Sydney Metro Martin Place

Over Station Development

Design Review Panel #08

25 February 2019

Awnings and weather protection

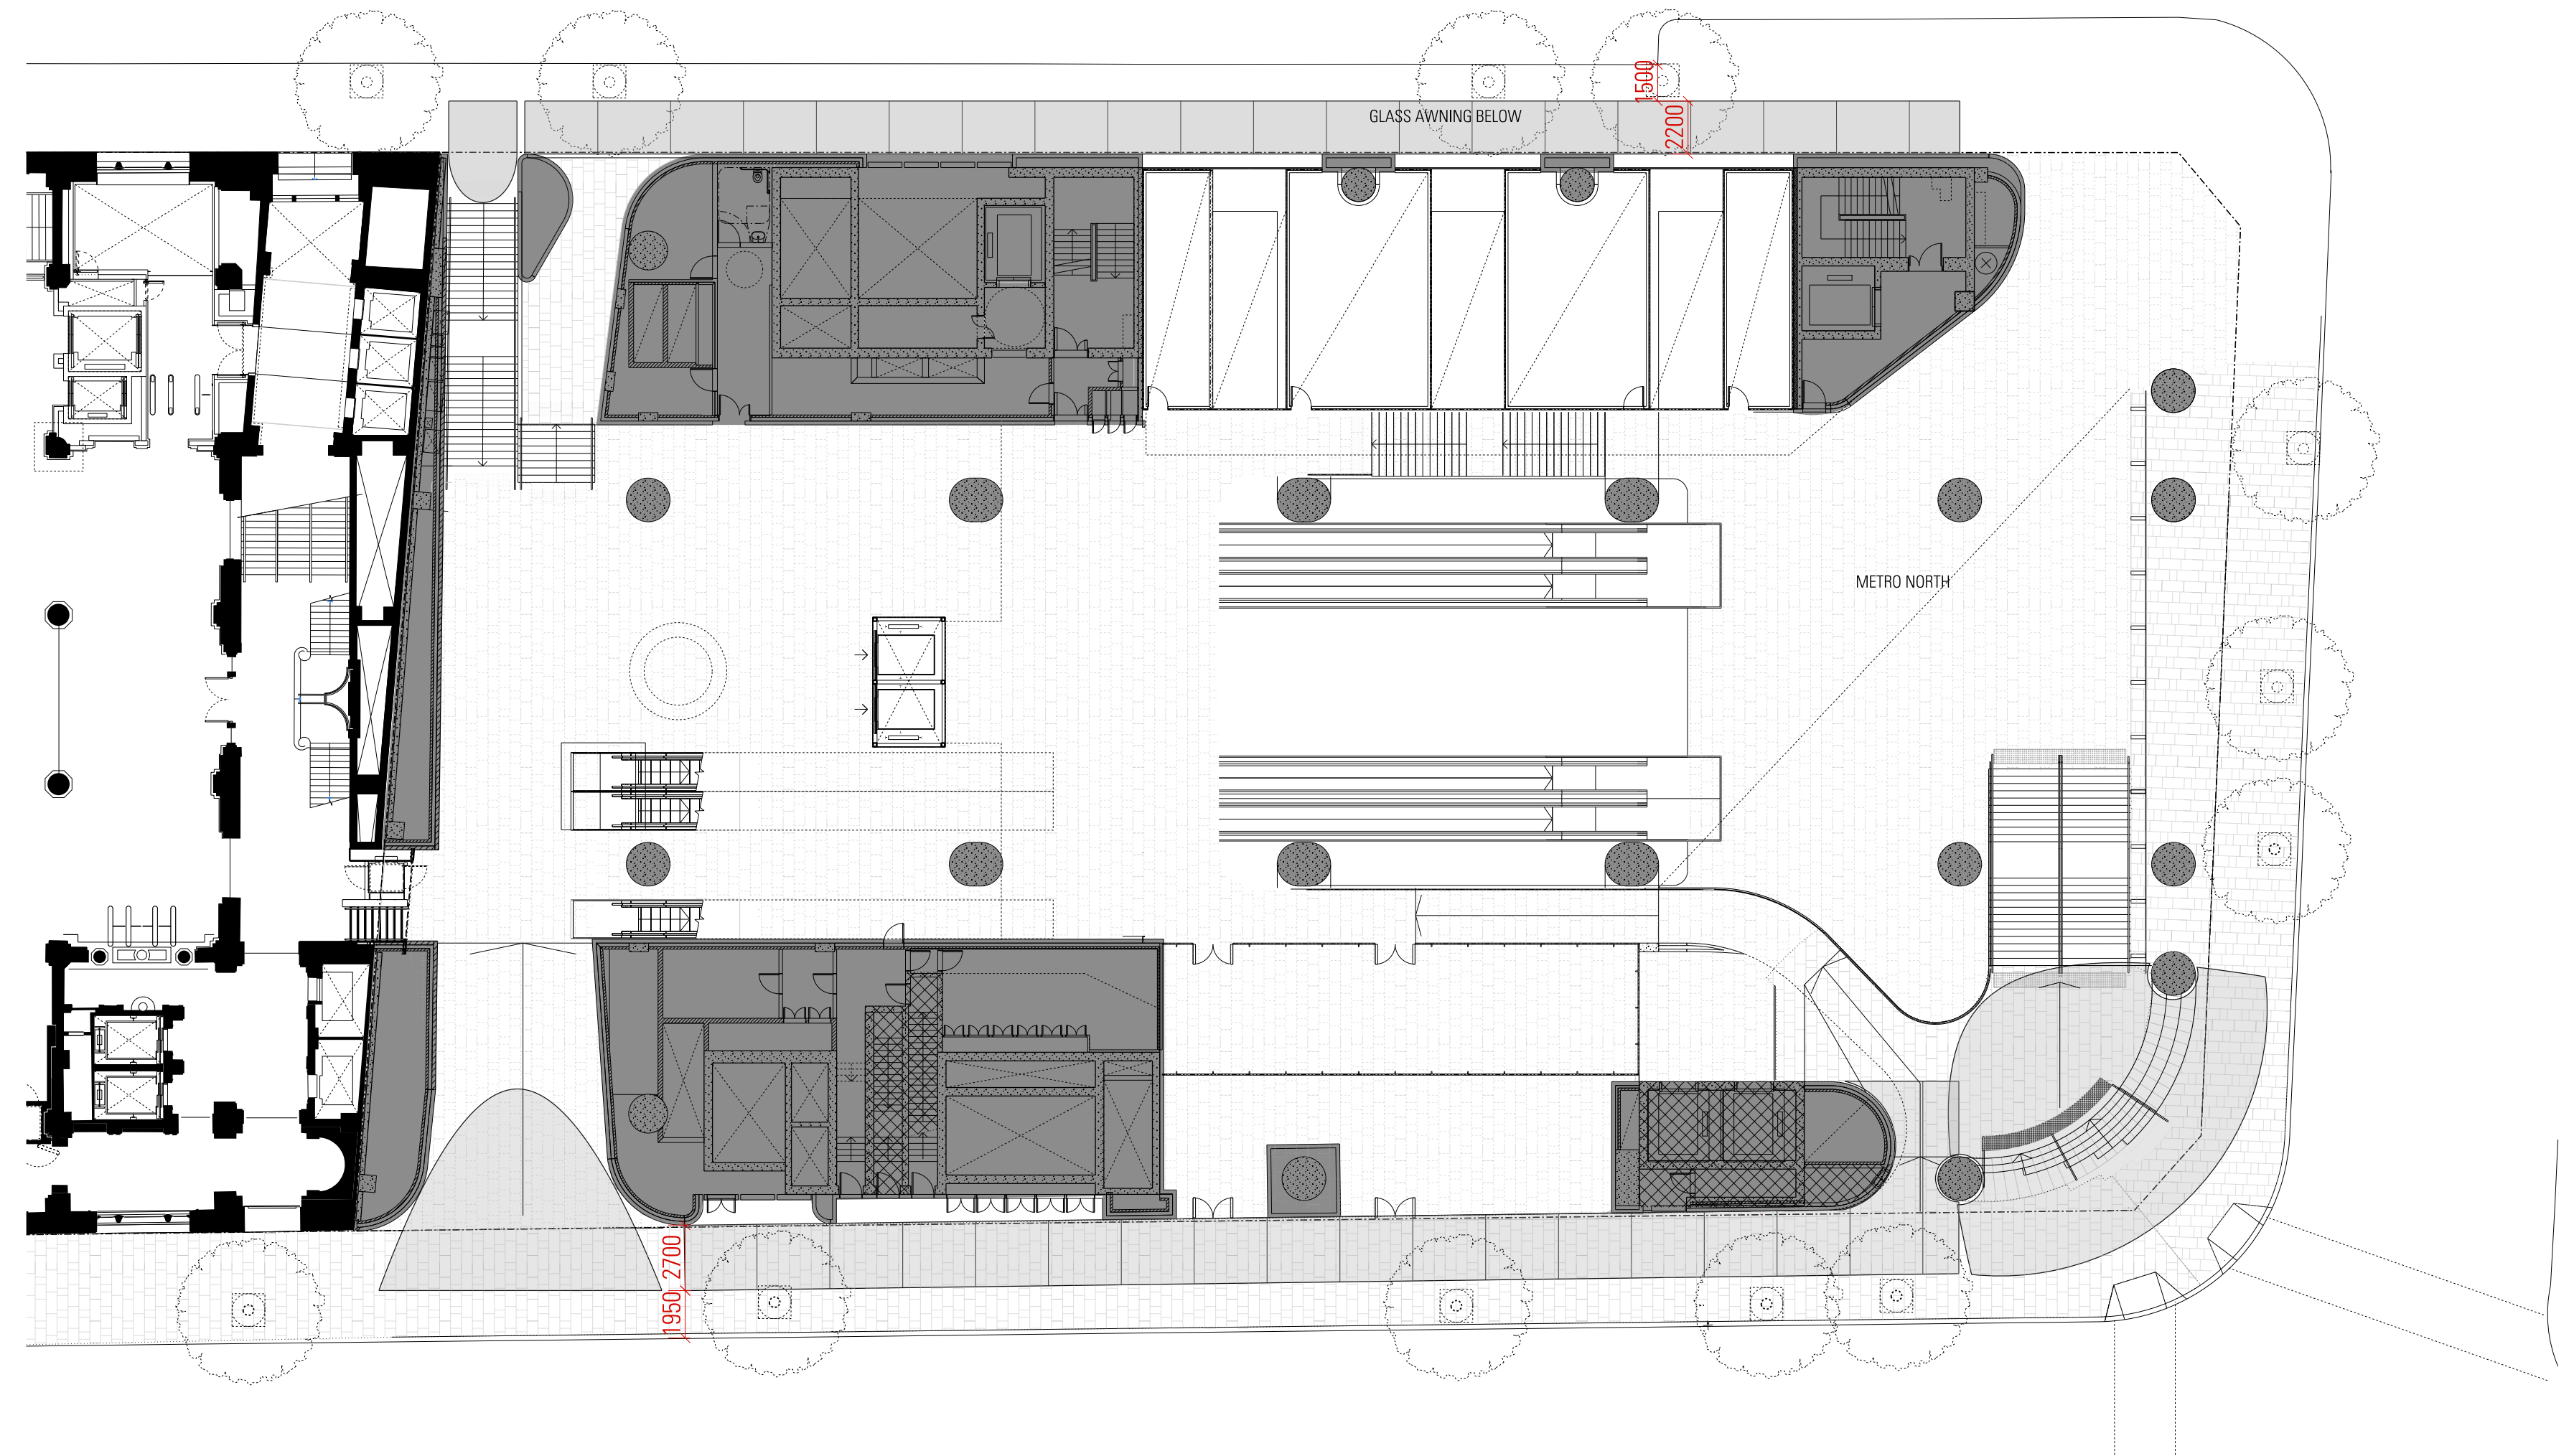
OSD DRP comment:

“While we support the awning proposal, we recommend it be lowered as far as possible to improve weather protection, particularly that portion of the awning which is raised to mark the entrance to the through site link.”

*“Further design refinement is required to **ensure the awnings which mark entrances to public and private spaces are differentiated.**”*

Station DRP comment:

*“The Panel encourages further review of the awning at the entry to the mid-block connection to **ensure that the station entry has an appropriate clarity and identity.**”*

*“Further design review of the awning above the entry to the mid-block connection on Elizabeth and Castlereagh Streets to ensure the awnings serve their intended purpose of weather protection and **give the station entry sufficient clarity / visual identity.**”*

Awnings and weather protection

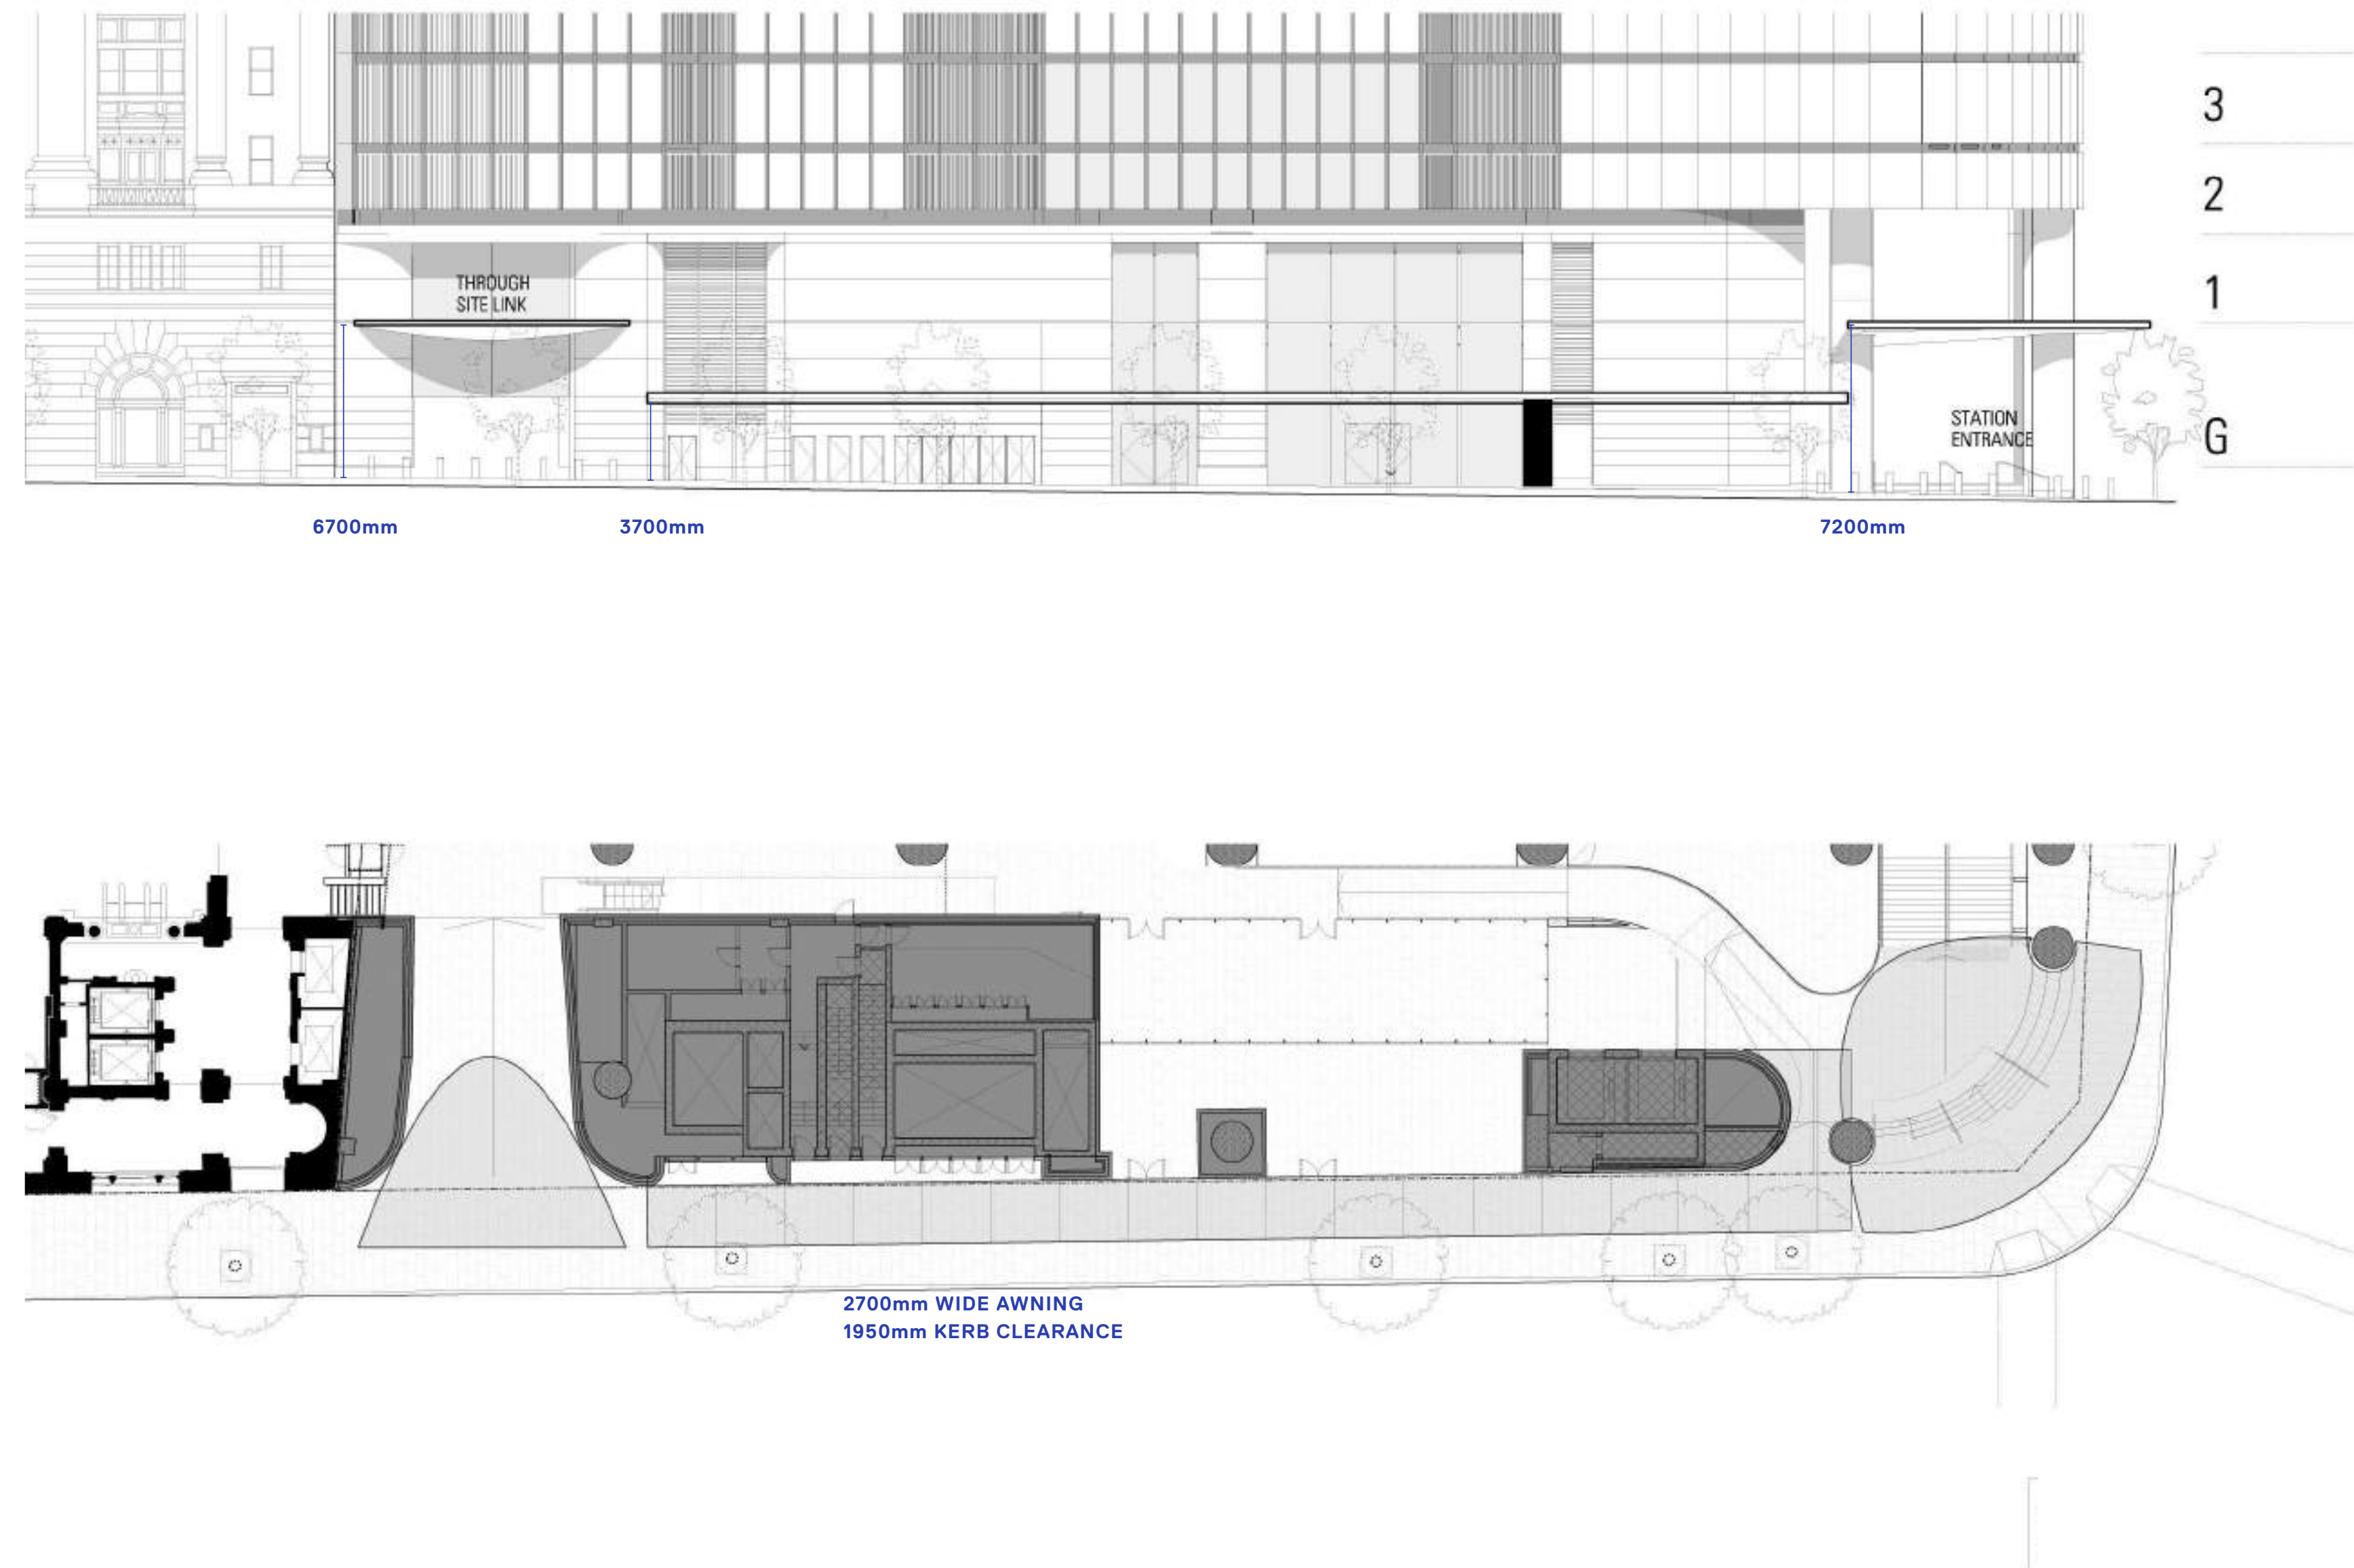
OSD DRP comment:

“While we support the awning proposal, we recommend it be lowered as far as possible to improve weather protection, particularly that portion of the awning which is raised to mark the entrance to the through site link.”

*“Further design refinement is required to **ensure the awnings which mark entrances to public and private spaces are differentiated.**”*

Station DRP comment:

*“The Panel encourages further review of the awning at the entry to the mid-block connection to **ensure that the station entry has an appropriate clarity and identity.**”*

*“Further design review of the awning above the entry to the mid-block connection on Elizabeth and Castlereagh Streets to ensure the awnings serve their intended purpose of weather protection and **give the station entry sufficient clarity / visual identity.**”*

Awnings and weather protection

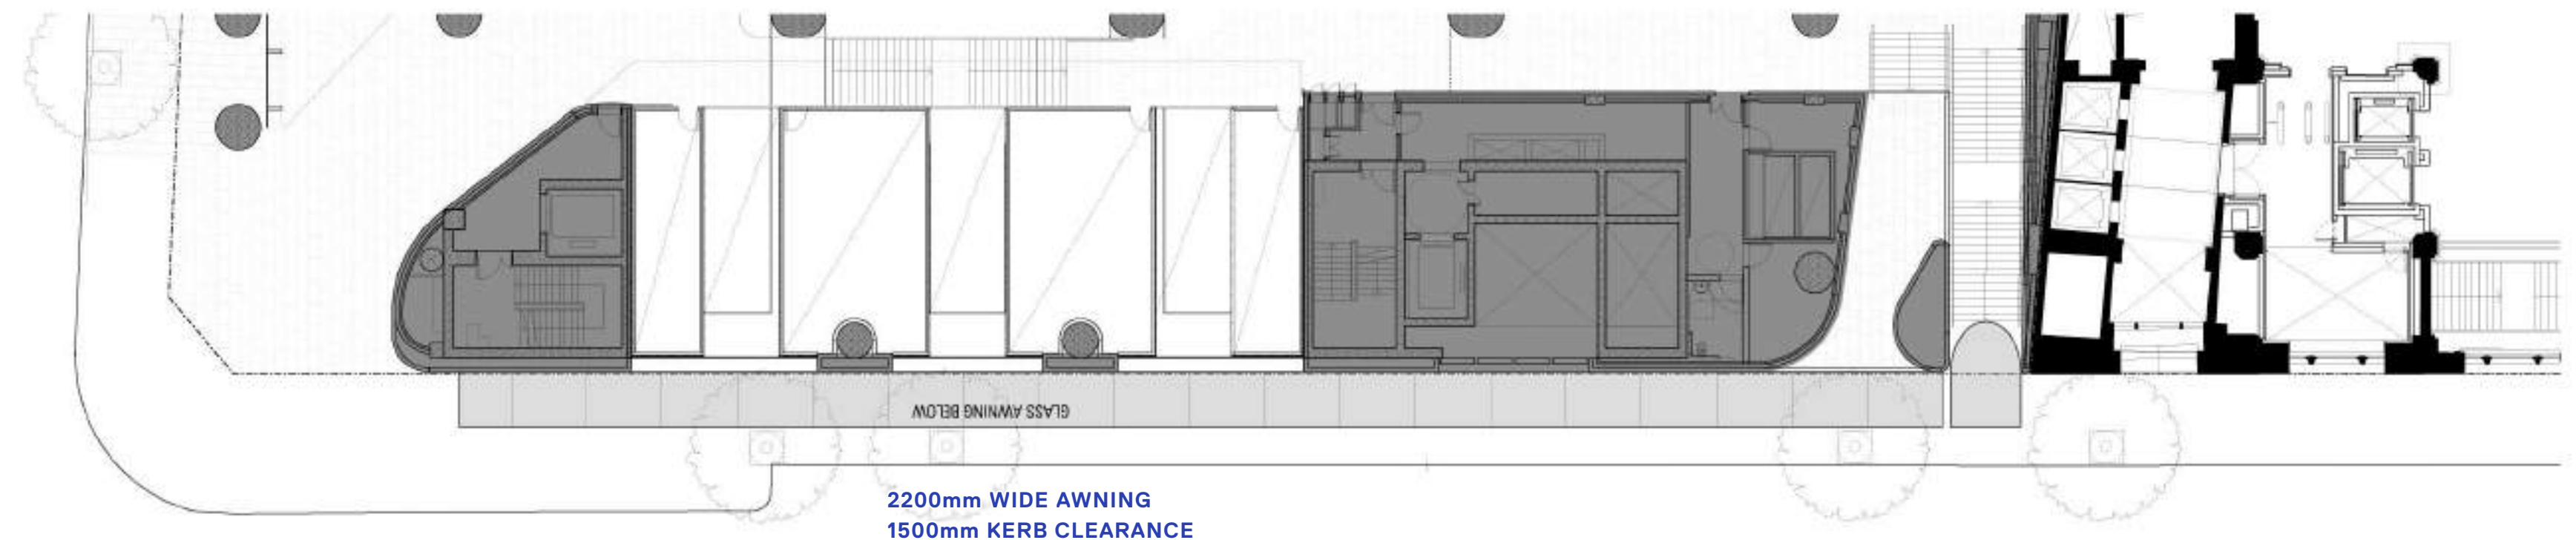
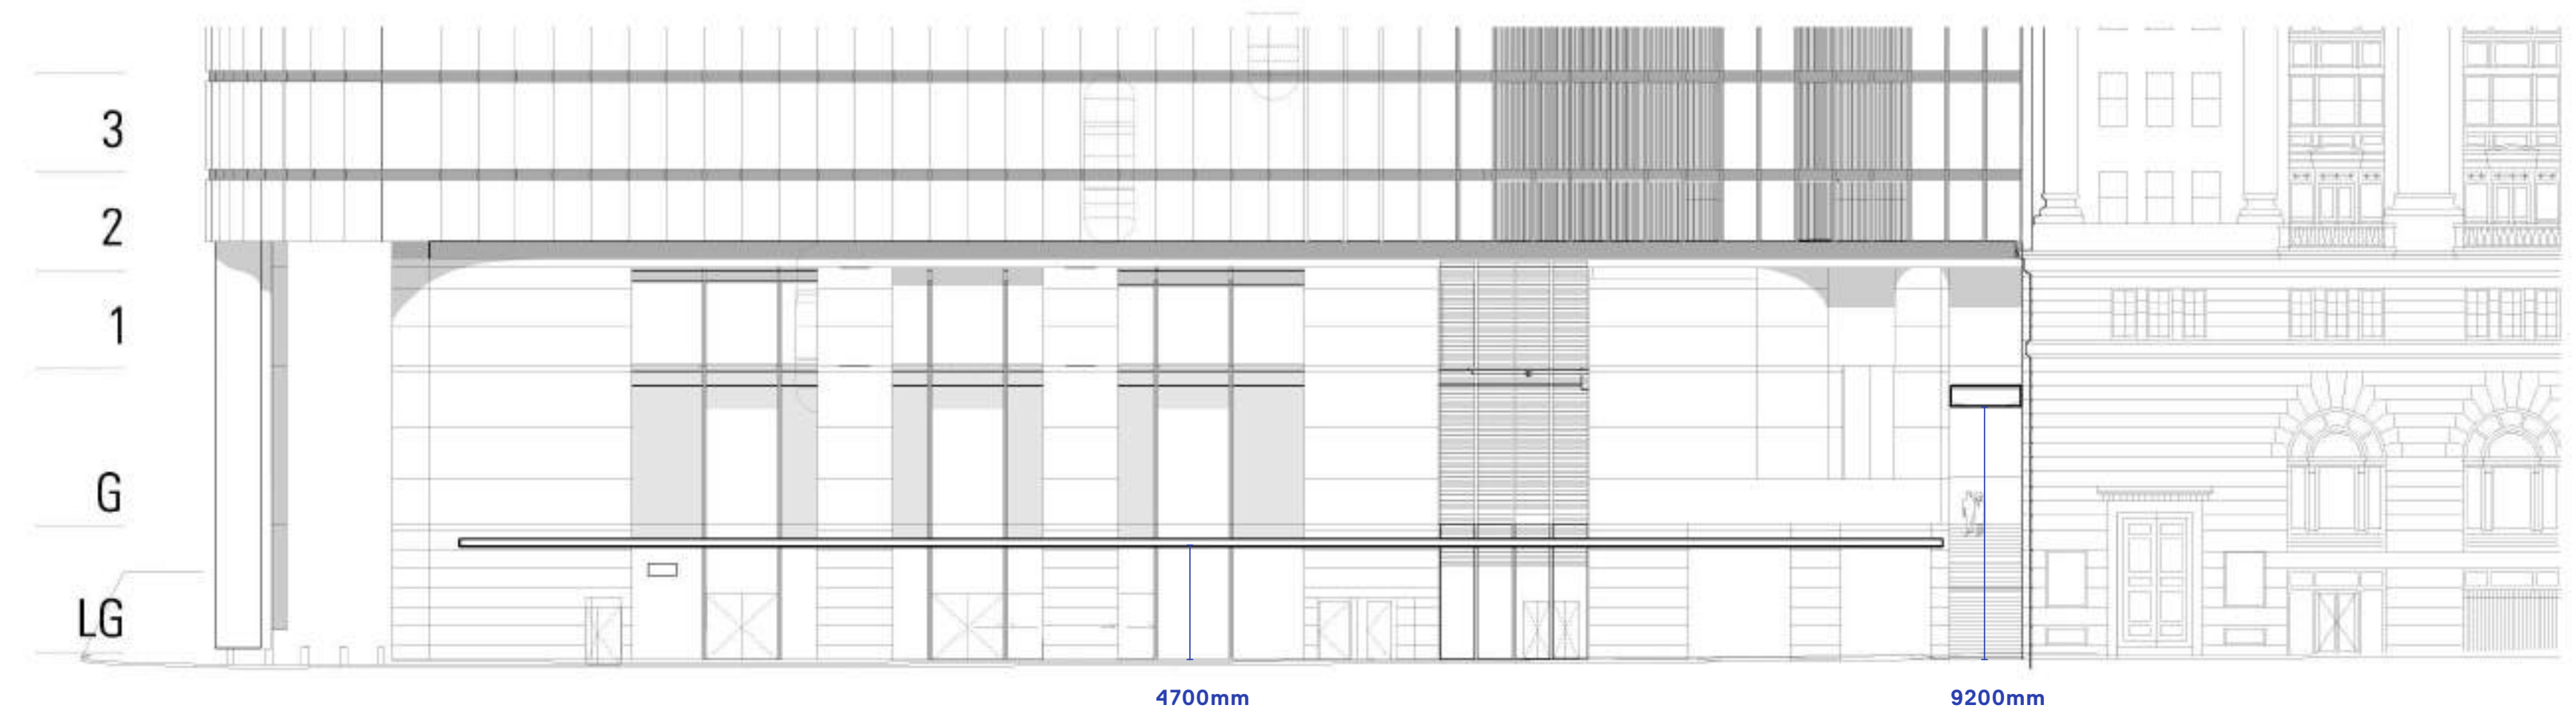
OSD DRP comment:

“While we support the awning proposal, we recommend it be lowered as far as possible to improve weather protection, particularly that portion of the awning which is raised to mark the entrance to the through site link.”

*“Further design refinement is required to **ensure the awnings which mark entrances to public and private spaces are differentiated.**”*

Station DRP comment:

*“The Panel encourages further review of the awning at the entry to the mid-block connection to **ensure that the station entry has an appropriate clarity and identity.**”*

*“Further design review of the awning above the entry to the mid-block connection on Elizabeth and Castlereagh Streets to ensure the awnings serve their intended purpose of weather protection and **give the station entry sufficient clarity / visual identity.**”*
